REQUEST FOR CERTIFICATE OF APPROPRIATENESS

MPC File No.: 25-000223-COA

Address: 538 East Bolton Street

Date: February 26, 2025

The following images show the changes on the east and west elevations. The approved drawings are on the left and the changes are on the right, clouded on the drawings.

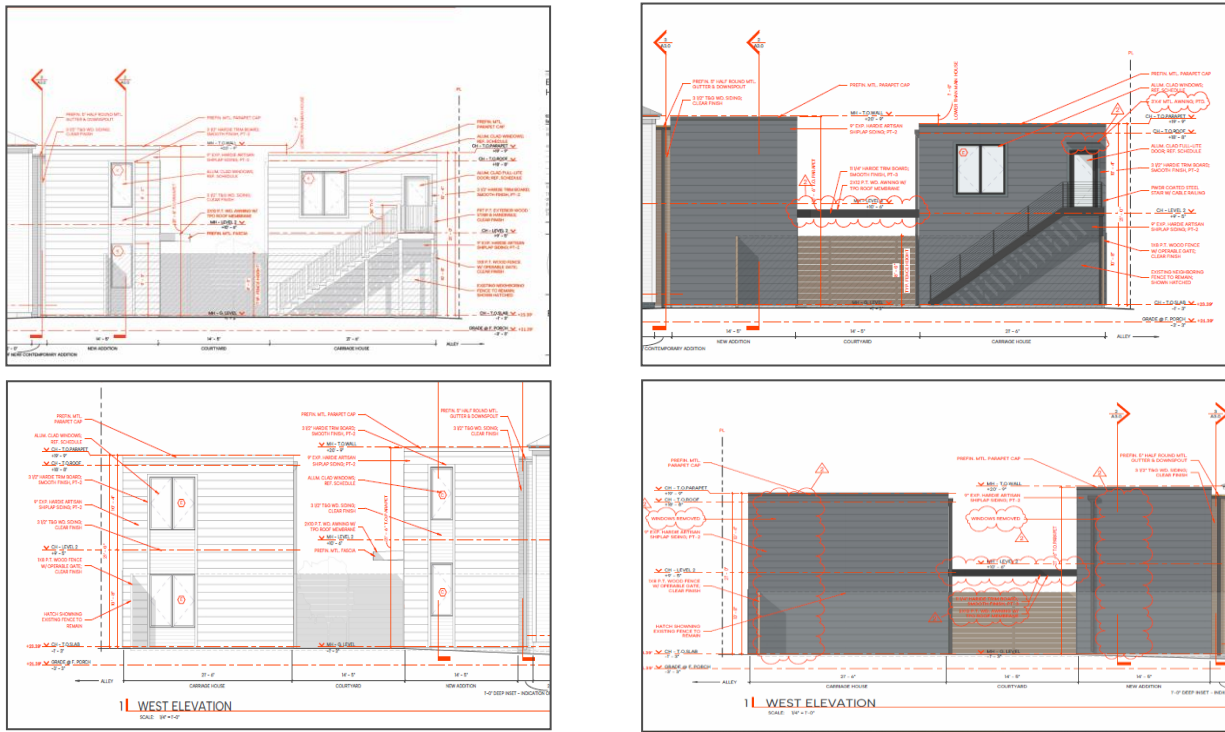
The applicant is requesting an after-the-fact amendment for the addition and accessory dwelling unit located at 538 East Bolton Street. The original project [23-000587-COA] was for rehabilitation of the existing historic house and the construction of an addition and an accessory dwelling unit. The current after-the-fact amendment work seeks approval for one awning that connects the addition and the ADU, one small awning over the second story door of the ADU, and for the omission of windows on the east and west elevations of the new addition and ADU.

In the case where previously approved windows were omitted from the design of the east and west elevations of the addition and the ADU, none of the facades of the addition or the ADU are visible from the street, only from the lane. The ground level is obscured by the fence and is not visible from the lane either (even though this standard is only referring to streets, not all public rights-of-way). Further, during the site visit, being inside the addition and ADU, there are still windows in each room on the north and south elevations.

The awning on the second story of the ADU is metal and the awning over the walkway between the addition and the ADU is wood. In both cases the standard is met.

Regarding the awning that does connect the addition to the ADU, staff finds that the intent of this standard refers to commercial buildings rather than private residential property. The extension of the original awning creates a covered walkway or breezeway that may function more as a courtyard area. Also, the section below addresses how this type of configuration is allowable for ADUs.

The rear addition of the house is connected to the ADU via a covered walkway. This deviated from the stamped drawings where there was originally a wood awning just at the rear of the addition. A change was made to extend the awning which has created the covered walkway. Staff finds that this is still aligned with the design standards and can remain.

Approve the after-the-fact amendment for the addition and accessory dwelling unit located at 538 East Bolton Street, from the previously approved design [23-000587-COA] as requested because the work is visually compatible and meets the standards.
